# ALERT SERVICE BULLETIN

**DOORS - Sliding doors**  
**Addition of a label on the sliding door cover**

[ASB AS555-52.00.15](https://www.airbushelicopters.com/techpub/ASB_AS555-52.00.15)

Figure 1

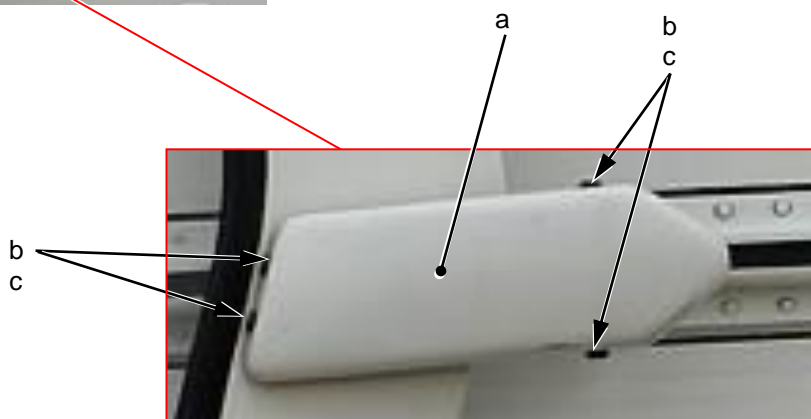
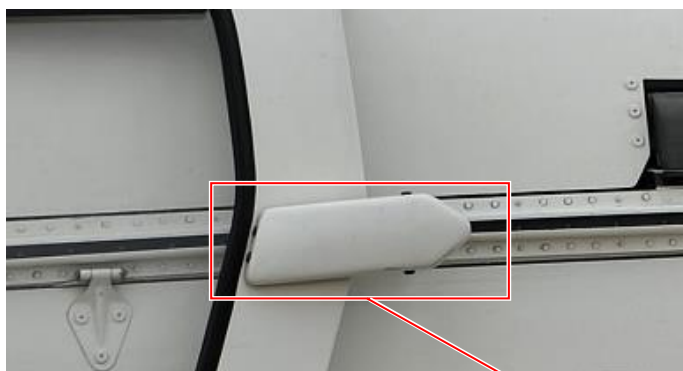
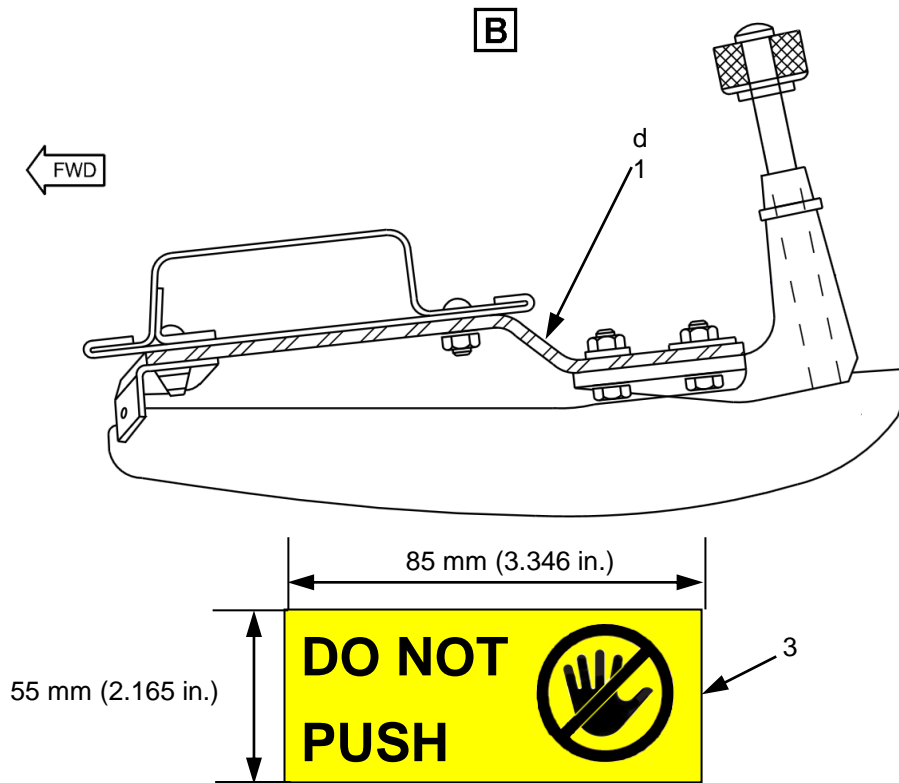
###### 3.B.2.a. Removal of the cover (a), (Figure 1)

- Remove the screws (b) and the washers (c) ([Figure 1](#))
- Remove the cover (a).

3.B.2.d. Installation of the LH rear support cover (a), (Figures 1 and 2)

- Remove the locally made label from the cover (a), if necessary.
- Install the LH rear support cover (a) ([Figure 1](#)).
- Install the washers (c) and the screws (b).
- Tighten the screws (b).
- Install the locally made label (3) on the LH rear support cover (a) as per Detail C, [Figure 2](#).

Figure 2

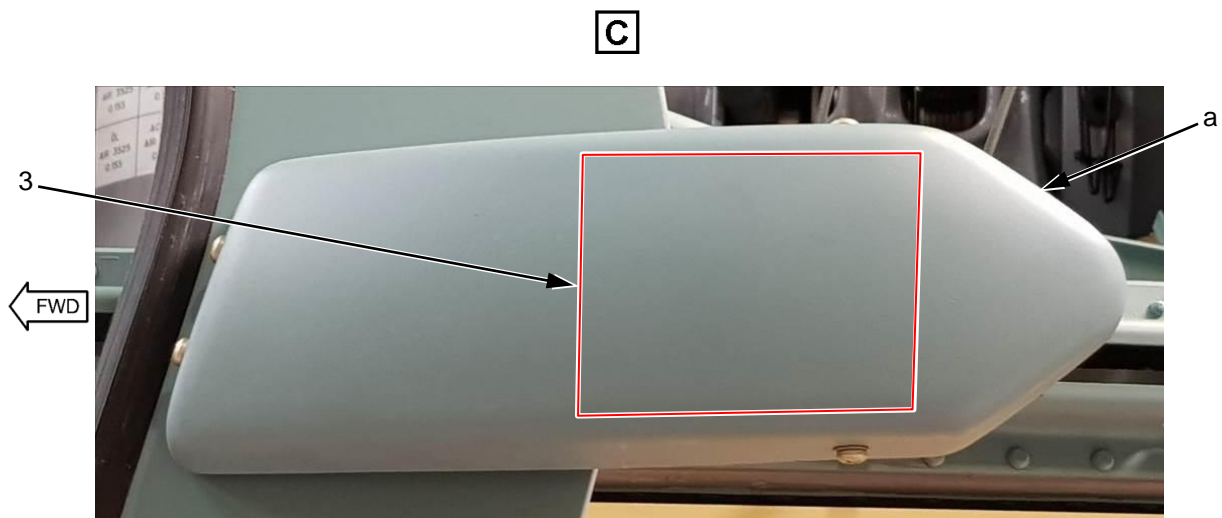
###### 3.B.2.b. Check of the LH rear support (d) (Figures 2 and 3)

- Make sure that there is no crack on the LH rear support (d) ([Figure 2](#)).
- . If there is no crack on the LH rear support (d):
  - .. install the cover (a) as per paragraph 3.B.2.d.
- . If there is a crack on the LH rear support (d):
  - .. replace the LH rear support (d) as per paragraph 3.B.2.c.,
  - .. if the LH rear support (1) is not available:
    - ... flights are authorized until receipt of the LH rear support (1) if the door is kept closed,
    - ... bond a locally made label "DO NOT OPEN IN FLIGHT" (4) ([Figure 3](#)) to the inside of the LH sliding door so that the label is visible and legible to passengers,
    - ... on receipt of the LH rear support (1) install the LH rear support (1) as per paragraph 3.B.2.c.

###### 3.B.2.c. Replacement of the LH rear support (d) (Figure 2)

- Remove the LH rear support (d), ([Figure 2](#)) as per the principles of Work Card 52-91-10-403 (MET).
- Install the LH rear support (1) as per the principles of Work Card 52-91-10-403 (MET).
- Remove the label "DO NOT OPEN IN FLIGHT" if previously installed.
- Install the LH rear support cover (a) as per paragraph 3.B.2.d.

Making a self-adhesive label:

The letter size takes into account the label integration on the LH and RH covers.

Choose a size of letters that will be clearly visible to the ground technician or ground crew.

Black letters on yellow background for military versions.
